Index 630-010 Conduit Details - Embedded

COMMENTARY

COMMENTS AND RESPONSES

INDEX	SHEET
630-010	1 of 4

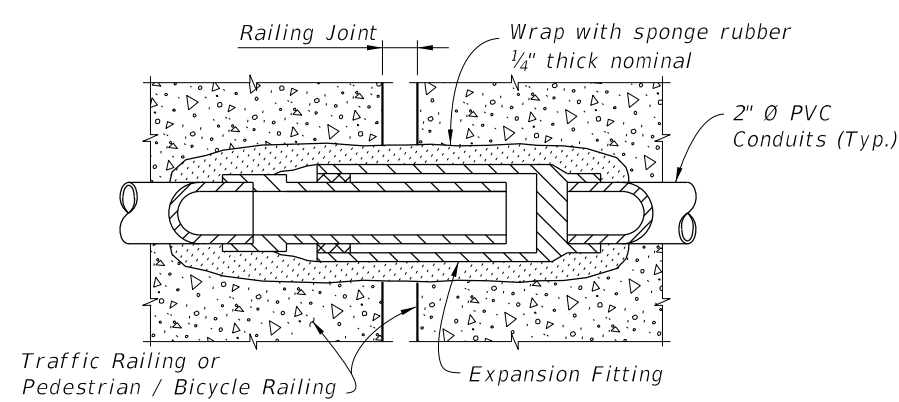
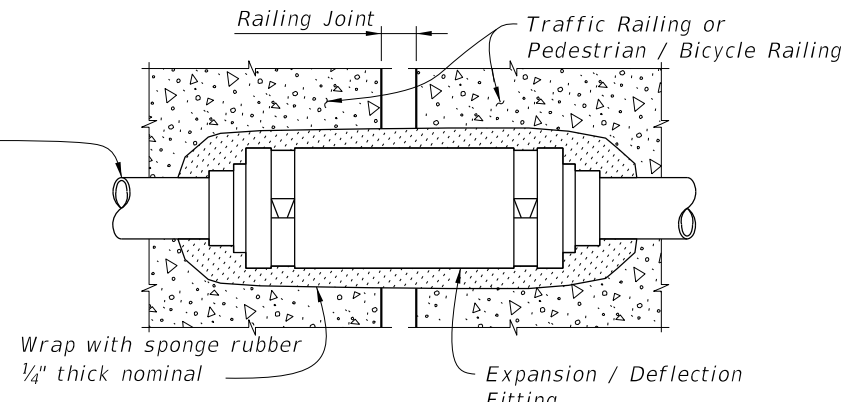
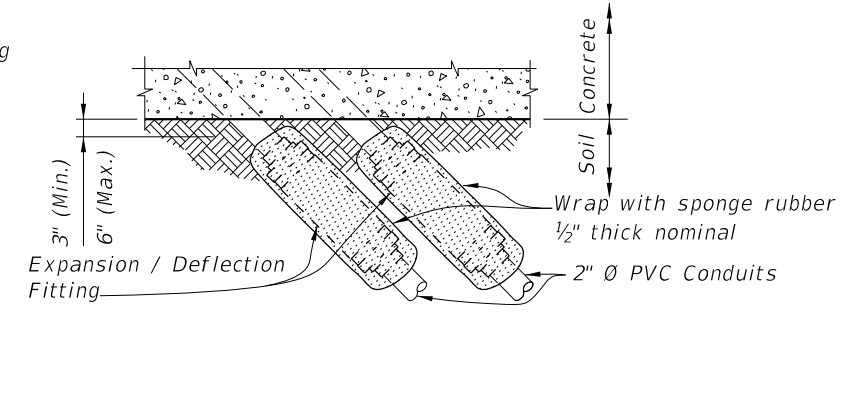
COMMENT: The draft proposes to add a comment of 1'-6" max elevation limit on pages 1,2 and 4 of SPI 630-010.

This is practical for the bridge traffic railings where the height of railing is 36" or more. Whereas, for the concrete parapet walls the height is 27" only.

Comment: Please evaluate the scenario and consider adding a note that for concrete parapet walls the maximum elevation to the top of conduit from coping is 14". Please note the 12" embedment for the anchor bolt on detail B.

RESPONSE: Thank you for your comment. We agree that a note should be added to cover this.

CHANGE MADE TO INDEX: Yes. Added elevation dimension details to Note 5.

5. Place conduits as indicated in this Standard unless Structures Plans indicate fewer.
Max elevation of the top of conduit is 1'-6" above top of coping for traffic barriers and 1'-2" for parapets.
